**MEADOWBROOK OFFICE BUILDING
(REVISED FACADE)
SP #07-68**

**MEADOWBROOK OFFICE BUILDING (REVISED FACADE), SITE PLAN NUMBER
07-68**

Meadowbrook Office Building (Revised Façade Materials)

Re: FACADE ORDINANCE – Preliminary and Final Site Plan Review
Meadow Office Building (SP-07-68)
Façade Region: 1
Zoning District: OST
Size: (1) Building – 2 story, 40,706 Sq. Ft.

REDUCED SITE PLAN

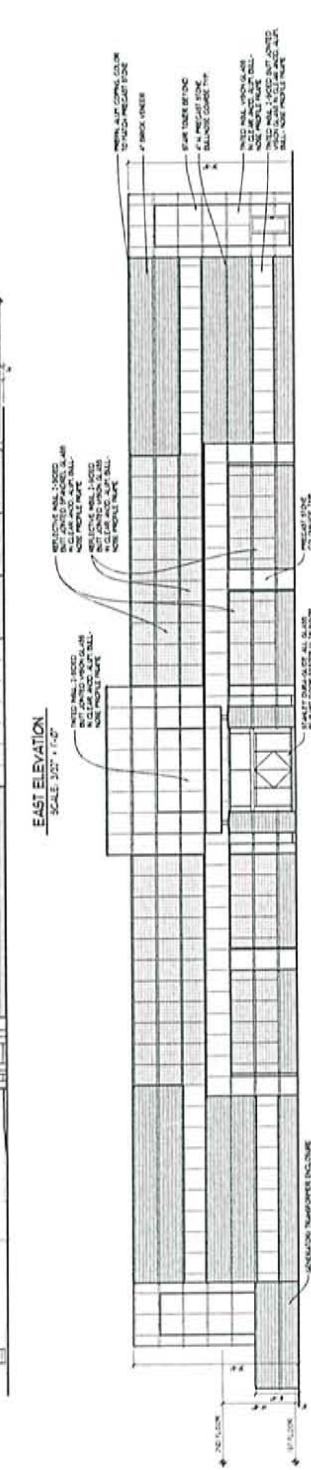
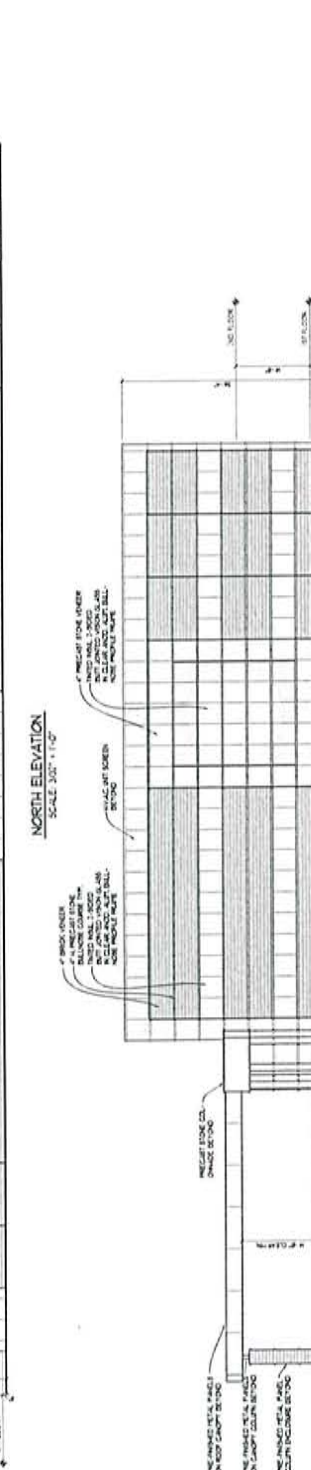
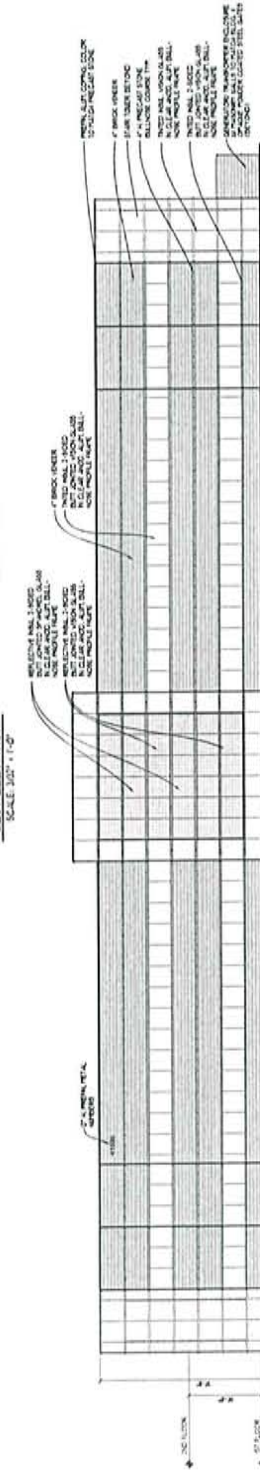
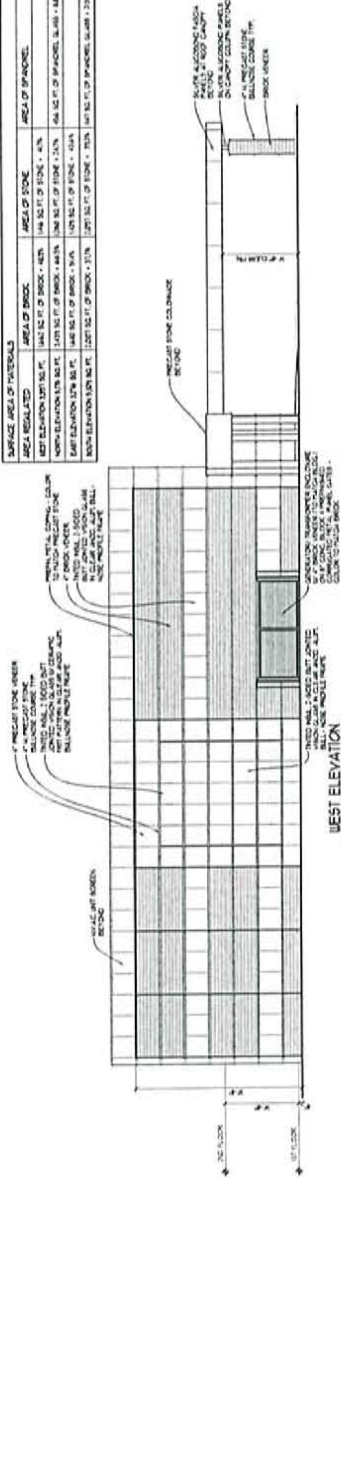
- **Site Plan Review and Approval:** Per Section 2516.1.b.(7).iii. of the Zoning Ordinance, changes to the façade design or sample board of a previously-approved site plan shall be reviewed and approved by the Planning Commission. On the revised plans/Stamping Sets, clearly differentiate between the approved façade (dated 12.2.05) and the built façade (dated 12.22.06) on the site plan drawings.

The following is the Façade Review for Preliminary and Final Site Plan review regarding the drawings prepared by Ron Jona & Associates, dated 12-22-06 for compliance with Novi Ordinance 2520; the Façade Ordinance. The percentages of materials proposed are as shown below. A "check" by the percentage signifies that the range is within the ordinance guidelines, while an "x" indicates an overage. The maximum percentages allowed by the Schedule Regulating Façade Materials are shown in the right hand column. **This review is based on material changes after the original stamping set was approved. The types and percentages of the new materials are consistent to those previously approved, except the color and/or texture have been modified. The applicant has provided a well written letter of intent, dated December 4, 2007, for consideration.**

1. Façade Revisions – As required under the Zoning Ordinance, we are now requesting a review and approval of changes made to the façade design and sample board for the previously approved site plan. After such review and approval, we will submit six revised copies of the façade drawings which clearly differentiate between the approved façade and the built façade for inclusion in the Stamping Sets of plans.

Eastbound on 12 Mile

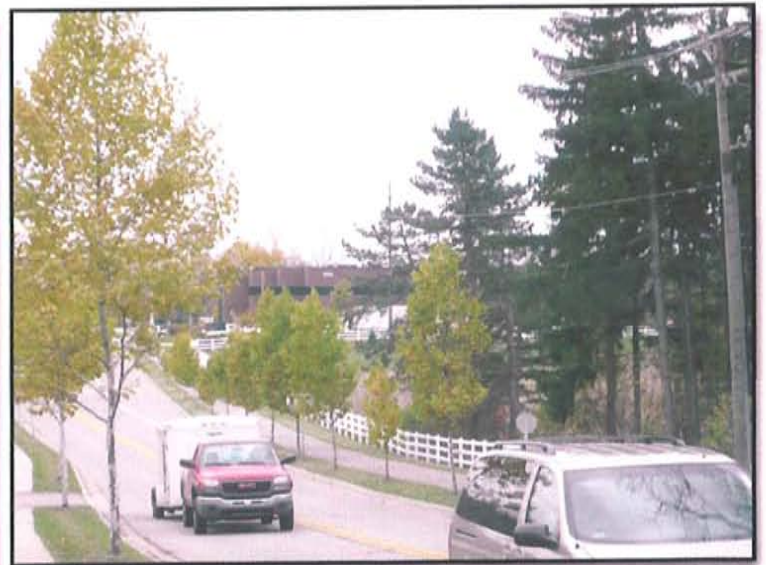
- **Elevations:** Per Section 2520.3 of the Zoning Ordinance, rooftop equipment must be screened from the roadway and adjacent properties. As shown in the photographs of the site, the rooftop equipment is readily visible from portions of both 12 Mile Road and Meadowbrook Road. However, while the applicant indicates he does not wish to attract more attention to the rooftop with additional screening, the size and shape of the units are too obtrusive to not warrant additional screening. As noted in the Façade Consultant's review, in order to meet the standards of Section 2520 of the Zoning Ordinance, additional screening of the rooftop units (in a dark color compatible with the building trim) is required to appropriately block the view of the structures from the adjacent properties and roads.

3. The applicant is seeking relief of the typical material requirements for the rooftop mechanical equipment, based on limited viewing and suggesting that adding traditional screening would make the units more noticeable. After visiting the site, no mechanical equipment is visible from the applicant's site, but they are visible from the neighboring community. Please see attached photos for reference. In some of the photos the profile of the units are noticeable. Painting the units would not enhance or disguise the nonrectangular shapes. It is our recommendation that the units be screened with materials that match the dark trim of the building. This screening may be physically attached to the units rather than traditional methods, but the goal would be to simplify the profiles to simple rectangular shapes.

2. Rooftop Unit Screening – In response to your review letters and accompanying photographs of the site, we offer the following thoughts for further consideration. We do not dispute the fact that there is some visibility of the rooftop units from both Twelve Mile and Meadowbrook Roads. However, we do not believe that the “snapshots” present an accurate depiction of what is actually seen by the naked eye. To illustrate this, we respectfully request that the Commissioners do a personal drive-by to view the site from the same locations as presented in the photographs. It is our opinion that the existing condition of the rooftop view is consistent with the intent of the screening requirement and that the addition of traditional screening materials in this particular situation will be more conspicuous and thereby detract from the view (because such screening would be taller and wider than the units).

Regardless, if the Planning Commission desires additional screening, we will comply by installing an approved screening material. For this purpose, we have submitted a sample of the Envisor brand screening system. We would propose using the vertical system without any optional top trim. Please note that we have not yet obtained samples of all the available panel designs – we have only received a sample of the “wide rib” panel, which may not be the best design for this application. Based on the product literature, we believe that the “louver” panel design may be a better fit with the architecture. Also, the “wide rib” panel provided is not in the color that we would propose using – so, we have separately provided a sample of “slate gray” (which is probably the best of the available color selections). Under the circumstances, we would request that the final material selection be administratively approved by the Planning Department at a later time if the Planning Commission determines that additional screening is required.
